CHARLOTTE - MECKLENBURG
PLANNING COMMISSION

SUBJECT: Administrative Approval for Petition No. 2004-123 by S & R Development Company LLC.

PETITION # 2004-123

Project: **Prosperity Pointe Drivwood Court Charlotte, North Carolina**
 Sheet Title: **Rezoning Plan**

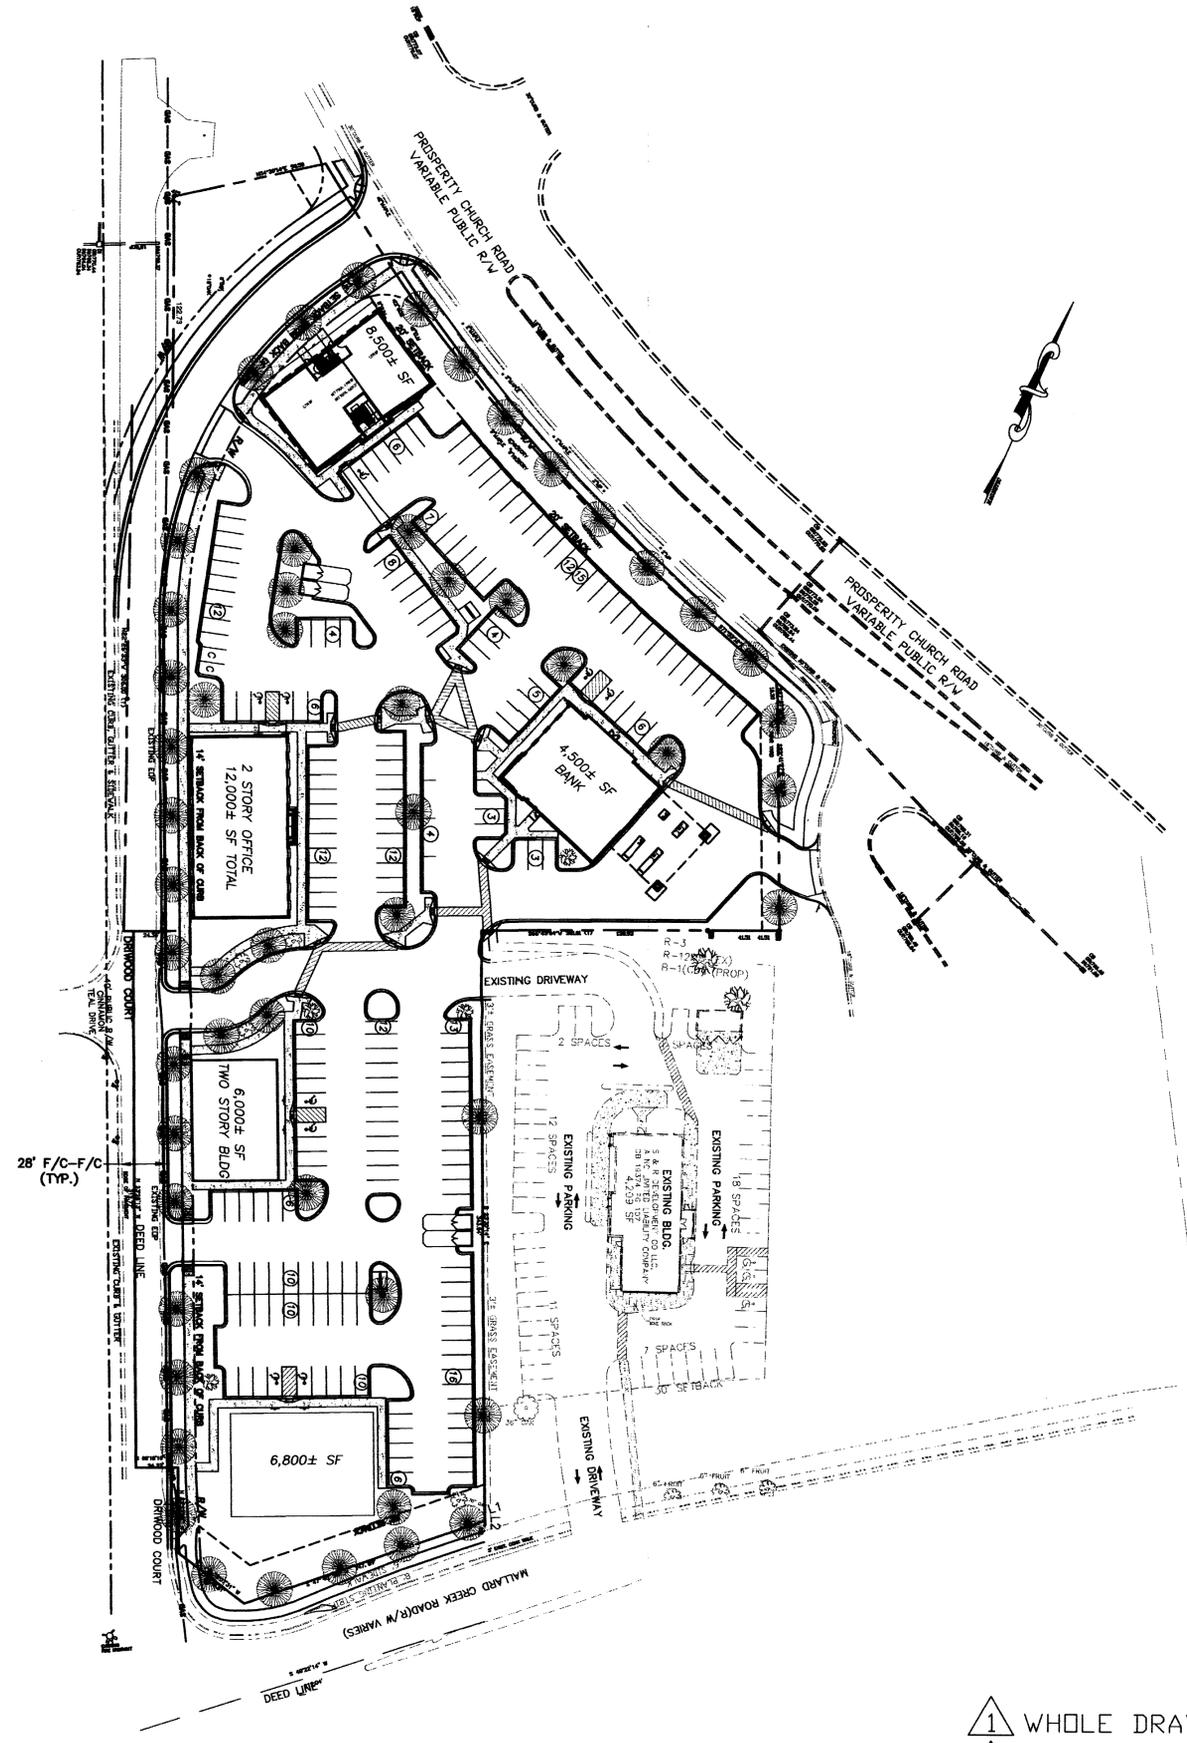
Attached is a revised plan for the above petition. The plan has been revised to show the location of the second bank, increase the allowable square footage by 1,000 square feet and show the building at the corner of Driwood Court and Prosperity Church Road at the fourteen foot setback. Since these changes are minor, I am administratively approving this revised plan. Please use this plan when evaluating requests for building permits and certificates of occupancy.

- MAXIMUM BUILDING HEIGHTS SHALL BE LIMITED TO 2 STORIES.
 - ALL USES PERMITTED WITHIN THE NS ZONING DISTRICT SHALL BE PERMITTED EXCEPT THAT COMMERCIAL USES ALLOWED ONLY IN THE B-1 DISTRICT AS PERMITTED WITHIN THE NS DISTRICT SHALL NOT BE PERMITTED. A MAXIMUM OF 36,800 SQ. FT. SHALL BE PERMITTED. THE PETITIONER REQUESTS AN INCREASE TO 37,800 SQUARE FEET UNDER THIS ADMINISTRATIVE APPROVAL. 2

- A MAXIMUM OF 2 FINANCIAL INSTITUTIONS WITH DRIVE THROUGH WINDOWS SHALL BE PERMITTED. AS PART OF THIS PROPOSED ADMINISTRATIVE APPROVAL THE PETITIONER REQUESTS A FINANCIAL INSTITUTION WITH DRIVE THROUGH WINDOWS TO BE LOCATED IN THE NORTH EAST CORNER OF THE SITE FACING PROSPERITY CHURCH ROAD (AS SHOWN). IF A SECOND FINANCIAL INSTITUTION WITH DRIVE THROUGH IS REQUESTED IT WILL BE LOCATED AT THE CORNER OF DRIWOOD COURT AND MALLARD CREEK ROAD AND WILL REQUIRE THE STAFF OF THE CHARLOTTE MECKLENBURG PLANNING COMMISSION TO APPROVE THIS USE ON AN ADMINISTRATIVE BASIS. 2

- THE TREES PREVIOUSLY SHOWN TO BE SAVED WERE REMOVED BY ADJACENT CONSTRUCTION OR HAVE DIED. 2
